UNITED STATES PATENT AND TRADEMARK OFFICE

APPLICATION NO.	FILING DATE	FIRST NAMED INVENTOR	ATTORNEY DOCKET NO.	CONFIRMATION NO.
10/582,954	07/02/2007	Satoshi Dodo	ASA-5384	9748
86636	7590	03/29/2010		
BRUNDIDGE & STANGER, P.C. 2318 MILL ROAD, SUITE 1020 ALEXANDRIA, VA 22314			EXAMINER WONGWIAN, PHUTTHIWAT	
			ART UNIT 3741	PAPER NUMBER
			MAIL DATE 03/29/2010	DELIVERY MODE PAPER

Office Action Summary	Application No. 10/582,954	Applicant(s) DODO ET AL.	
	Examiner PHUTTHIWAT WONGWIAN	Art Unit 3741

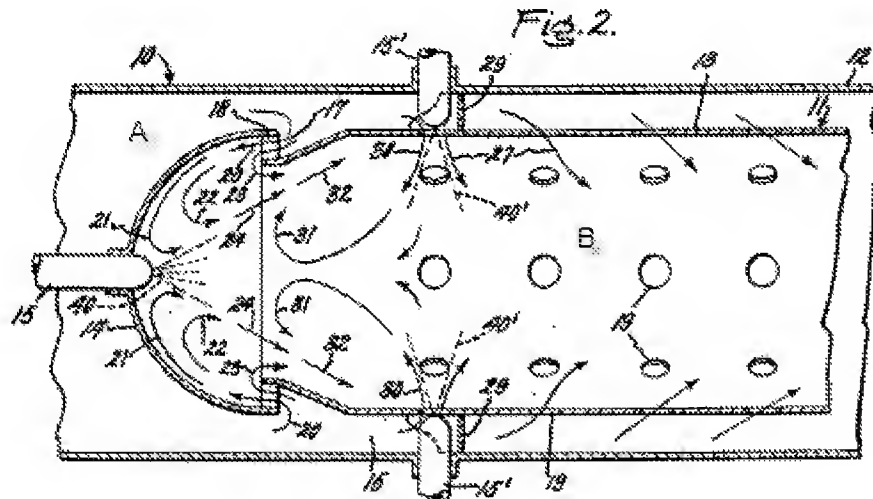
8. As best understood, claims 1-9 are rejected under 35 U.S.C. 102(b) as being anticipated by Johnson (US Patent No. 2,930,192).

9. As to claims 1-3 and 8, Johnson discloses a combustor for a gas turbine, comprising: a tubular 11 (fig. 2) combustor liner forming a combustion chamber B (fig. 2 above); an outer tube 10 (fig. 2) provided in an outer peripheral portion side of the combustor liner via a gap A (fig. 1 above); a first burner 15 (fig. 2) provided in one end (fig. 2) of the combustor liner and injecting a fuel 40 (fig. 2) and an air 21 (fig. 2) into the combustion chamber; an air introduction hole 19 (fig. 1) introducing a combustion air 30 (fig. 2) guided from the gap with respect to the outer tube into the combustion chamber B (fig. 2 above); and a second burner 15' (fig. 2) provided in the outer tube at a position

facing to the air introduction hole 19 (fig. 2) and directly injecting the fuel 40' (fig. 20 into the combustion chamber B (fig. 2 above) from the air introduction hole 19 (fig. 2 above), wherein the air introduction hole 19 (fig. 2) and the second burner 15' (fig. 2) are installed at a position corresponding to a leading end portion (fig. 2 above) of a flame generated by the first burner [inherent] , a flow speed of the air injected into the combustion chamber from the air introduction hole is made higher than a flow speed of a combustion gas around the air introduction hole [inherent], the air injected from the air introduction hole 19 (fig. 2) is brought into contact with each other within the combustion chamber so as to form a circulation jet flow (fig. 2 above), the air introduced into the combustion chamber from the air introduction hole is mixed with the combustion gas, and the fuel is slowly oxidized [inherent].

10. As to claims 4-7, Johnson discloses the second burner 15' (fig. 2) is provided so as to pass through a peripheral wall 11 (fig. 2) forming the combustion chamber, wherein the second burner 15' (fig. 2) is constituted by a plurality of burners 15' (fig. 2), and these plurality of burners are arranged in such that the fuel and the air come into collision with each other near a center portion of the combustion chamber (fig. 2 above), wherein the second burner 15' (fig. 2) is provided with a fuel injection nozzle 15' (fig. 2) near a center portion (fig. 2 above) of the combustion chamber such that the fuel is positioned in an outer side of a spray flow of the air (fig. 2 above) and wherein the second burner 15' (fig. 2) is provided with a guide tube 15' (fig. 2) guiding the fuel 40' (fig. 2) and the air 30 (fig. 2) to a center portion (fig. 2) of the combustion chamber, in a

peripheral wall 11 (fig. 2) forming the combustion chamber, and the guide tube protrudes into the combustion chamber.

11. As to claim 9, Johnson discloses a combustor (fig. 2 above) for a gas turbine comprising: a tubular combustor liner 11 (fig. 2) forming a combustion chamber B (fig. 2 above); an outer tube 12 (fig. 2) provided in an outer peripheral portion side of the combustor liner via a gap A (fig. 2 above); a pilot burner 15 (fig. 2) provided in an upstream side of the combustor liner and injecting a fuel 40 (fig. 2) and an air 21 (fig. 2) into the combustion chamber so as to secure a combustion stability [inherent]; and a lean air-fuel mixture guiding means 15', 19 (fig. 2) provided in a peripheral wall 11 (fig. 2) of the combustor liner and directly injecting the fuel 40' (fig. 2) and the air 38 (fig. 2) into the combustion chamber B (fig. 2), wherein a flow speed of the air injected into the combustion chamber from the lean air-fuel mixture guides means is made higher than a flow speed of a combustion gas around the lean air-fuel mixture guiding means [inherent], and the fuel and the air from the lean air-fuel mixture guiding means 15', 19 (fig. 2) are injected to a leading end portion of a flame generated by the pilot burner so as to form a circulation jet flow of the lean air-fuel mixture [inherent].
